Service Bulletin

Bulletin No.: 17-NA-406

Subject: Driveline Shudder Under Hard Acceleration Felt in Seat

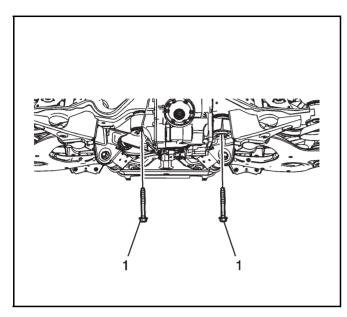
Involved Region or Country	North America		
Condition	Some customers may comment that a vibration is felt under heavy acceleration around 20 mph (32 km/h), which can be felt in the seat.		
Cause	This condition may be caused by a second order vibration from the cardan joint.		
Correction	4921286 If the vehicle has been validated to have a driveline shudder under heavy acceleration around 20 mph (32 km/h), install 4.5 mm thick shims (1) on top of the front RDM isolator bushings.

2279896

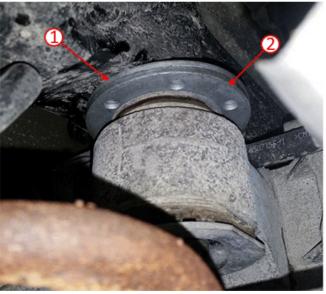
- 2. Remove one of the front differential bolts (1).
- 3. Loosen the opposite side front differential mount bolt.

- 4. Position the flat washer (1) over the differential mount washer (2).
- Loosely install the bolt enough to support the differential.
- 6. Remove the other front differential bolt and position the washer over the differential mount washer.
- 7. Install the bolt.
- 8. Tighten the bolts to specifications. Refer to Fastener Specifications in SI.
